<b>Well Name:</b> POKER LAKE UNIT 25 BD N	<b>Well Location:</b> T25S / R30E / SEC 25 / TR B / 32.107694 / -103.831058	<b>County or Parish/State:</b> EDDY / NM
<b>Well Number:</b> 504H	<b>Type of Well:</b> OIL WELL	<b>Allottee or Tribe Name:</b>
<b>Lease Number:</b> NMLC063079A	<b>Unit or CA Name:</b> POKER LAKE UNIT	<b>Unit or CA Number:</b> NMNM71016X
<b>US Well Number:</b> 3001557594	<b>Operator:</b> XTO PERMIAN OPERATING LLC

**Notice of Intent**

**Type of Action:** Drilling Operations

**Procedure Description:** James Metcalf, Wells Engineer- Delaware Basin for XTO Permian Operating, LLC. received verbal/email approval from Zota Stevens, Petroleum Engineer with BLM-Carlsbad, on February 27, 2026, to conduct sidetrack operations as follows: 9-5/8" casing set at 1,455' with cement to surface WELL SUMMARY: While drilling the intermediate, at 6,202' we tripped for a motor failure. While tripping out pulled tight and pulled the mandrel off the catch, leaving a tool at 4,920'. We tripped in with a mill to clean out the hole and pushed the fish to bottom. The new top of fish was 6,179'. Plan forward was to plug back the Cherry Canyon and drill a sidetrack in the Salado. EXECUTED PLAN

# Proposed Wellbore

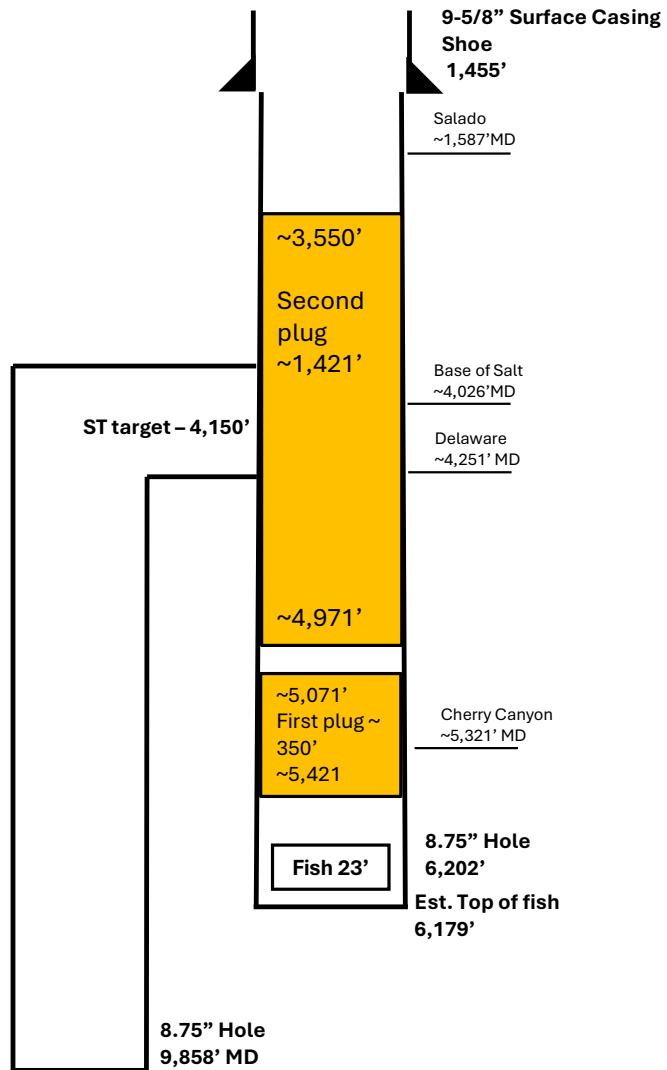
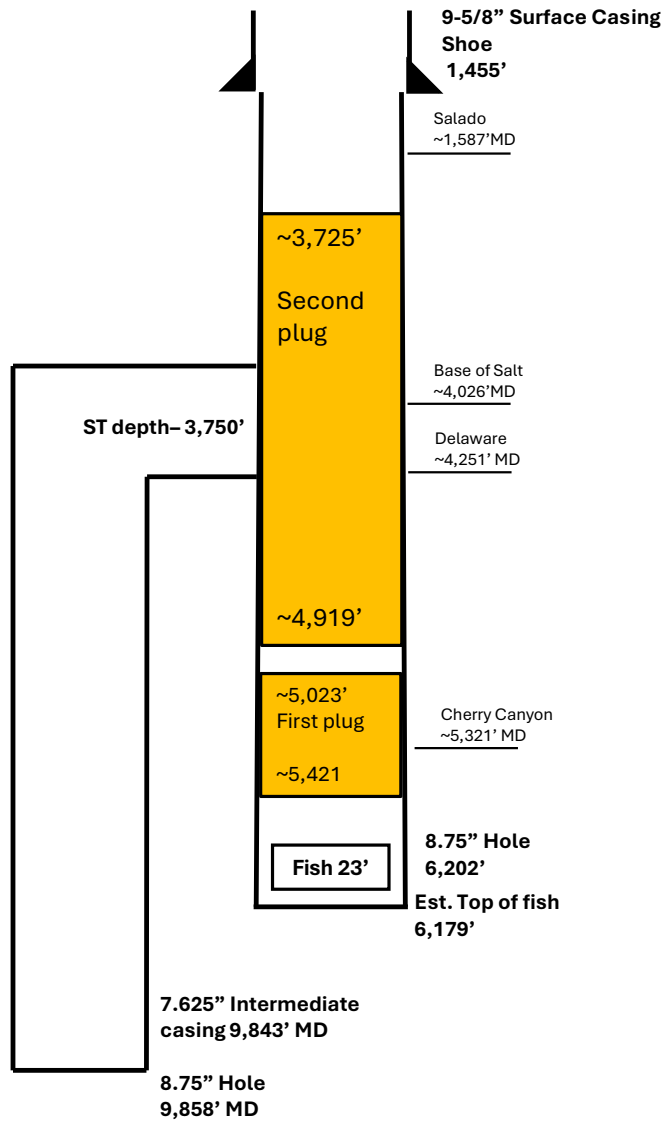
**While drilling the intermediate, at 6,202' we tripped for a motor failure. While tripping out pulled tight and pulled the mandrel off the catch, leaving a tool at 4,920'. We tripped in with a mill to clean out the hole and pushed the fish to bottom. The new top of fish was 6,179'. Plan forward was to plug back the Cherry Canyon and drill a sidetrack in the Salado.**

**Set cement plugs and sidetrack around the fish.**

**Cement plugs were set as follow:**

Plug 1: 135 sacks (33 bbls) of Class C Cement (1.34 ft<sup>3</sup>/sk, 14.8 ppg) will be set from 5,023'-5,421' MD

Plug 2: 650 sacks (110 bbls) of Class H cement (0.96 ft<sup>3</sup>/sk, 17.5 ppg will be set from 3,725'-4,919' MD.

**We then sidetracked off the 2<sup>nd</sup> cement plug at 3,750'.**

**There will be no changes to our production interval. Production casing and cement requirements will remain unchanged.**

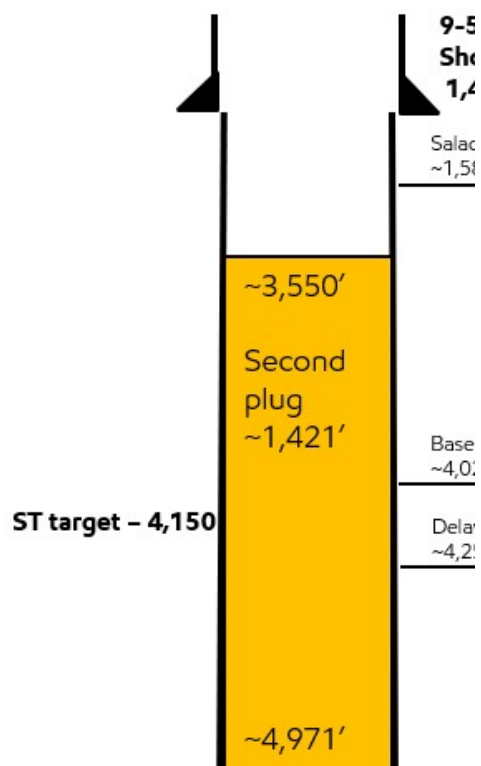
Thank you for the conversation this morning. Per your requirements we will be isolating the Cherry Canyon from the Delaware and the Delaware from the Base of Salt. Our sidetrack strategy will remain unchanged. With the current bottom hole and fish in the Cherry Canyon, 800'+ above the Brushy Canyon, cement will not be placed directly on top of the fish. Please see image below.

Base of Salt: 4,026' MD  
Delaware: 4,251' MD  
Cherry Canyon: 5,321' MD  
Est Top of Fish: 6,179' MD  
Bottom hole depth: 6,202' MD  
Brushy Canyon (not penetrated): 7,066' MD

Plug1 (Base/Cherry Isolation Plug): M&P ~30 bbls 14.8 ppg cement from 4550' MD to 4900' MD (350' length) – TOC confirmed with TAG

Plug 2 (Kick Off/Delaware Isolation Plug): M&P ~110 bbls 17.5 ppg cement from 4971' MD to 3550' MD (1421' length) – TOC confirmed with TAG and ST operations

On the fish left in the hole, you will need to see if you can pump cement down and cement the fish in place ending with cement top at 6100’ – WOC and Tag. – Top of Brushy  
Spot cement from 5400’ to 5200’ – WOC & Tag – T Cherry  
Spot cement from 4300’ to 4100’ – WOC & Tag – T Delaware
